# Access Compliance Report

## Public Rights-of-Way

### (Curb Ramps)

Intersection ID: 13817	Main Street: SHENANDOAH_AV	Cross Street: WESTOVER_ST	Location: W
ADA ID: D2CBF3479778	Ramp Type: PerpDiag	Initial Pass/Fail: Fail	Overall Compliance: No
Severity Score: 22.5			
Codes/Mitigation Info/Possible Solution		Field Measurements/Component Compliance

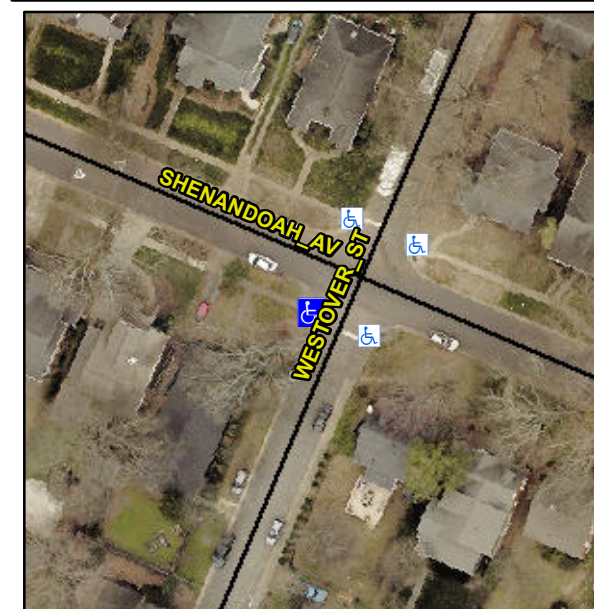
**Not Found, R304.5.1, R304.2.2, R304.5.3**

Compliance	Description	Data	Compliance	Description	Data
N/A	Ramp Length (in)	61.0	No	Ramp Slope (%)	9.4
No	Ramp Width (in)	38.0	No	Ramp XSlope (%)	4.0
N/A	Flare Type LT	N/A	N/A	Flare Type RT	N/A
N/A	Flare Slope LT (%)	N/A	N/A	Flare Slope RT (%)	N/A
N/A	Flare Traversable LT?	N/A	N/A	Flare Traversable RT?	N/A
N/A	Landing Length (in)	N/A	N/A	DWS Provided?	N/A
N/A	Landing Width (in)	N/A	N/A	DWS Contrast?	N/A
N/A	Landing Slope (%)	N/A	N/A	DWS Length (in)	N/A
N/A	Landing X Slope (%)	N/A	N/A	DWS Full Width?	N/A
N/A	Landing Curb? (Y/N)	N/A	N/A	DWS Offset (in)	N/A
N/A	Shared Landing?	N/A			
N/A	Gutter Ponding?	N/A	N/A	Gutter Slope (%)	N/A
N/A	Gutter Lip Ht (in)	1.0	N/A	Gutter X Slope (%)	N/A
N/A	Painted X Walk1?	No	N/A	Painted X Walk2?	No
	X Walk 1 Direction	To NE		X Walk 2 Direction	To SE
N/A	X Walk 1 Width (in)	N/A	N/A	X Walk 2 Width (in)	N/A
	X Walk 1 Slope (%)	0.3		X Walk 2 Slope (%)	4.4
	X Walk 1 X Slope (%)	5.3		X Walk 2 X Slope (%)	2.1

**Remove & Replace Curb Ramp With Two New Directional Ramps or Equivalent.**
